Attachment A

Landscape & Public Domain Clarifications

12023 - 31 Wheat Road Darling Harbour, Sydney **ASPECT Studios**[™]

Public Domain Plan

Dwg no. : 12023-LSK 01

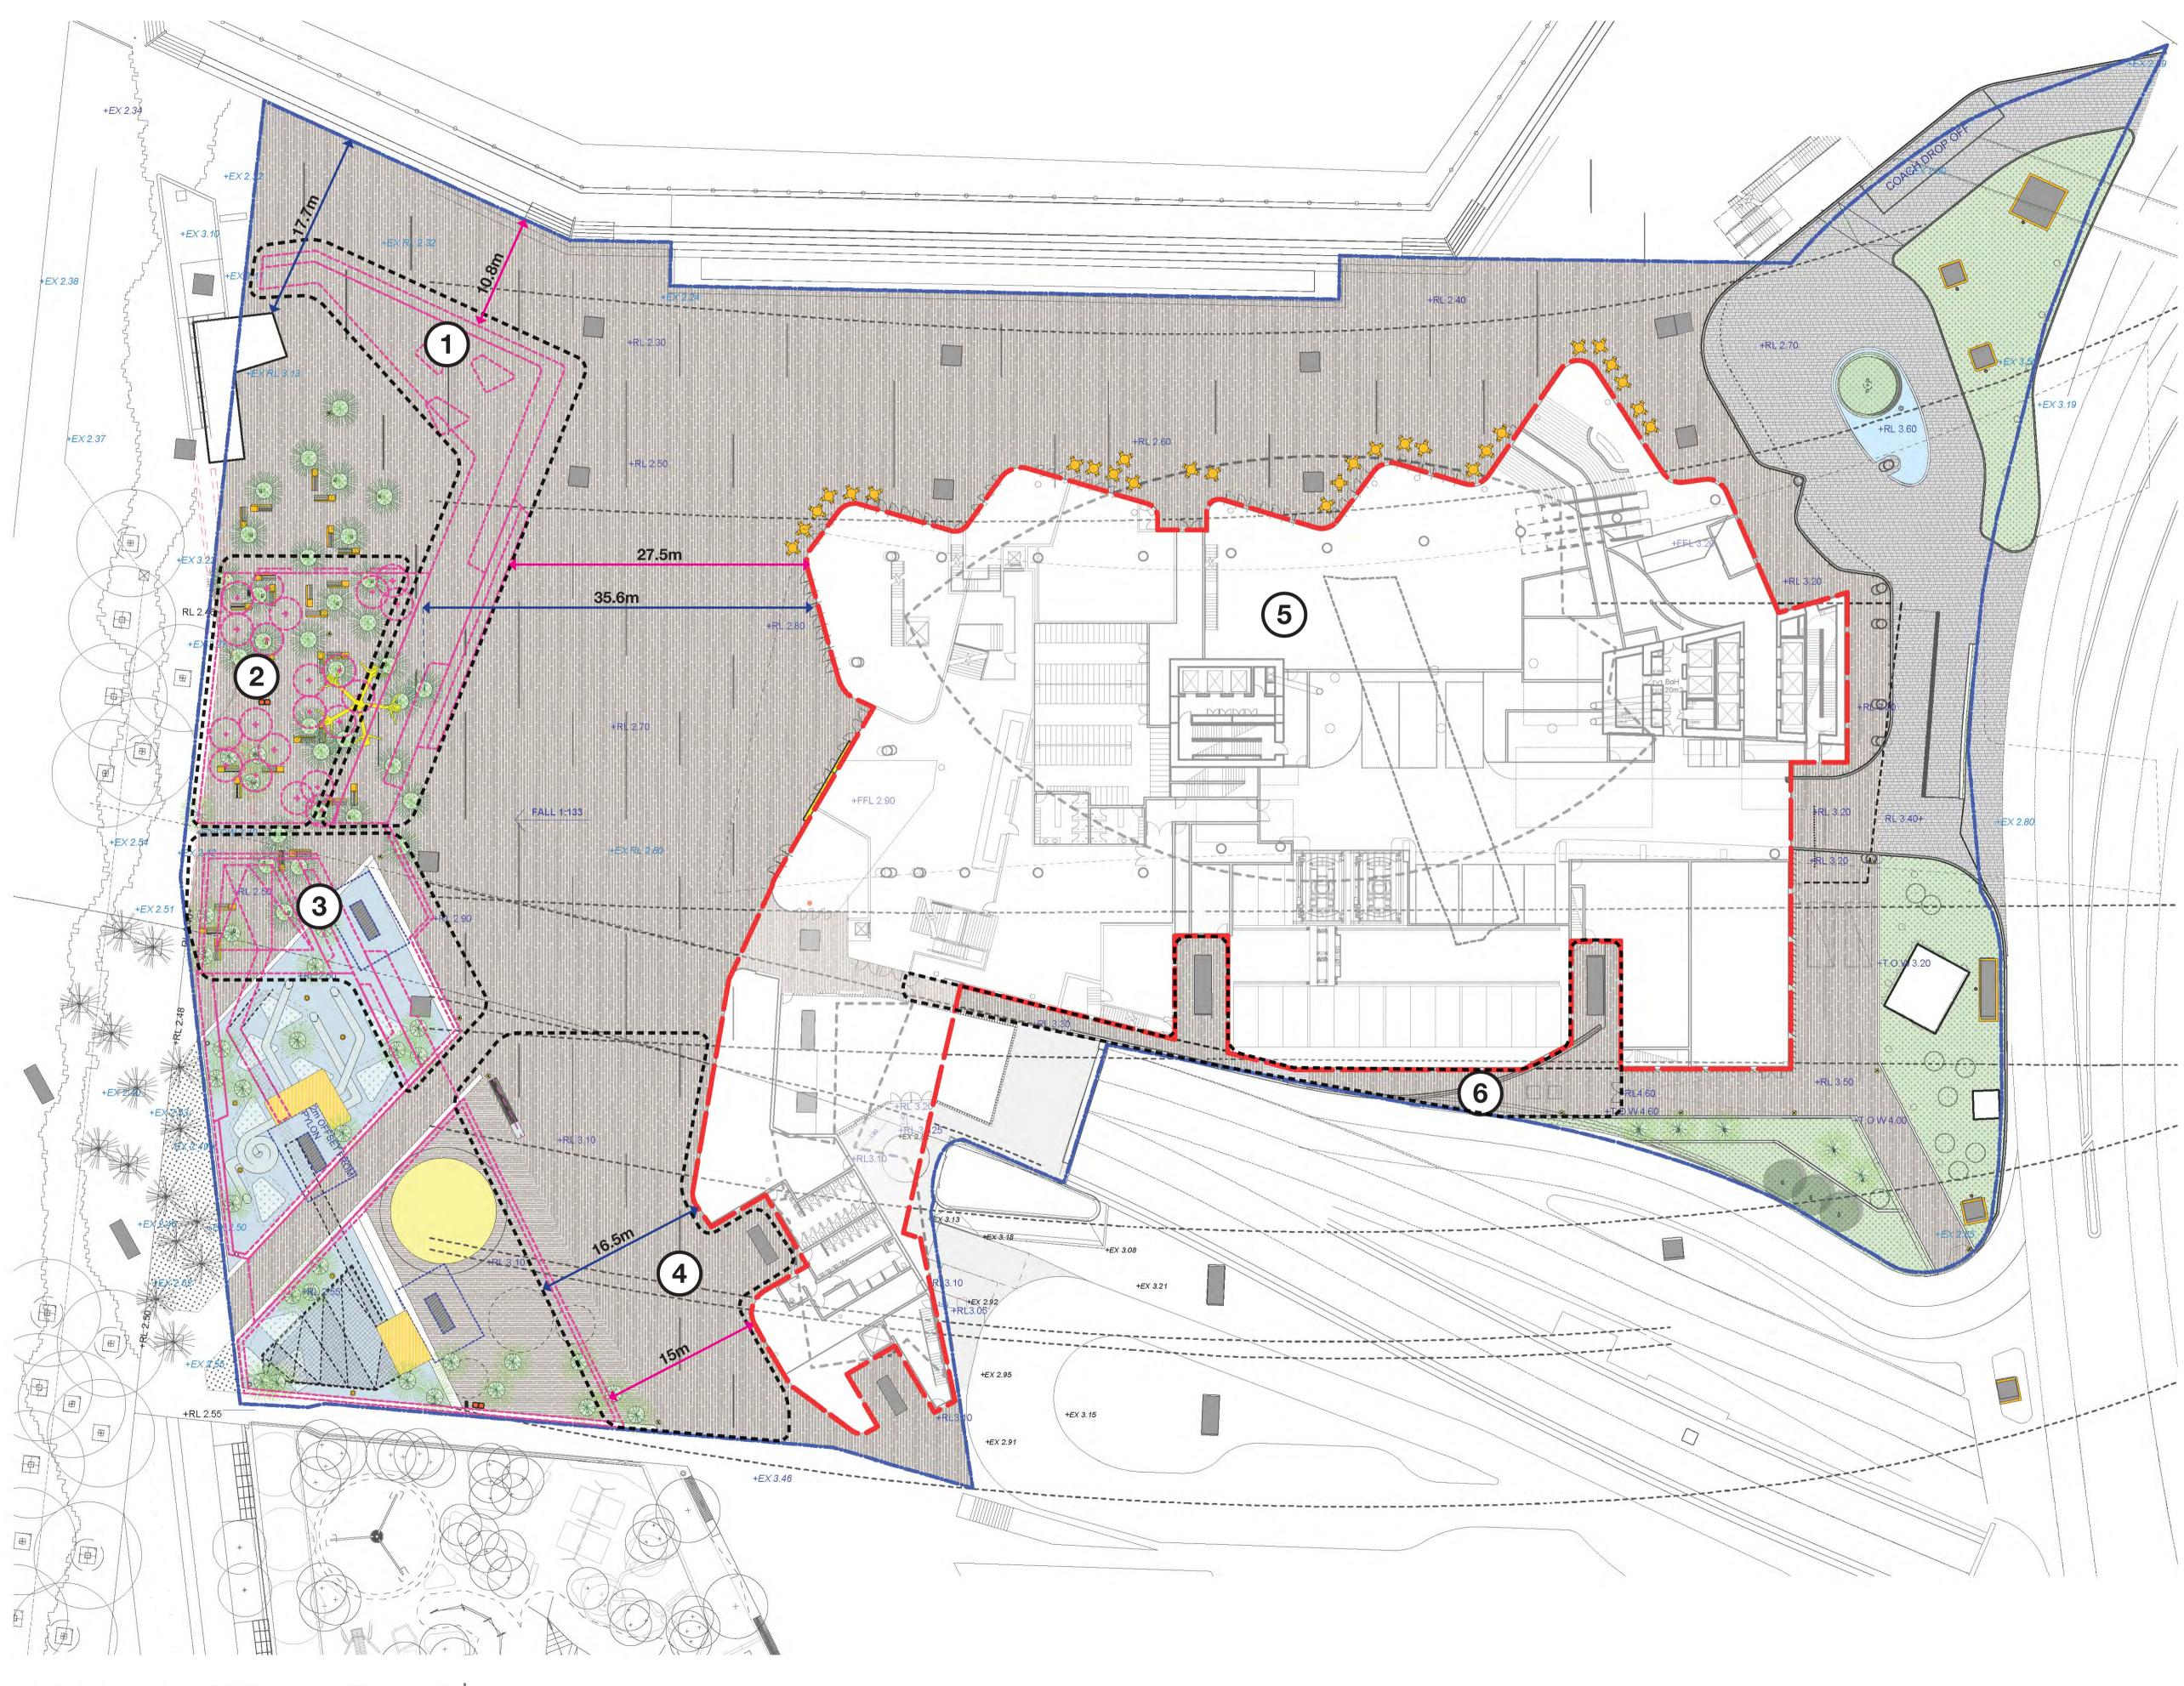
- Removal of the large timber deck to the east of the control building to allow increased circulation space along the waterfront and larger flexible event space.
- Previous DA [Rev F] dimension: appox.10.8m / New dimension: appox.17.7m

- Removal of raised turf area and replace with paving to ensure the continuation of materiality and levels in public domain and allow permeability from boulevard adjacent.
- Propose bespoke seating under relocated palm grove.
- Relocation of Jay Flowers Sculpture to a more prominent/ visible location.

• Removal of climbing net structure and climbing wall to increase permeability from adjacent boulevard and maximise views to harbour.

- Alignment of the west edge of pedestrian boulevard with the existing Darling Quarter playground edge.
- Introduction of flush edge to access relocated carousel and playspace.
- Width of pedestrian boulevard reduced due to increased floor plate of proposed building to the east.
- Previous DA [Rev F] dimension: appox.15m / New dimension: appox.16.5m

• Updated Architectural base of Ribbon Building.

Restricted access to southern edge of hotel as a response to CPTED analysis.
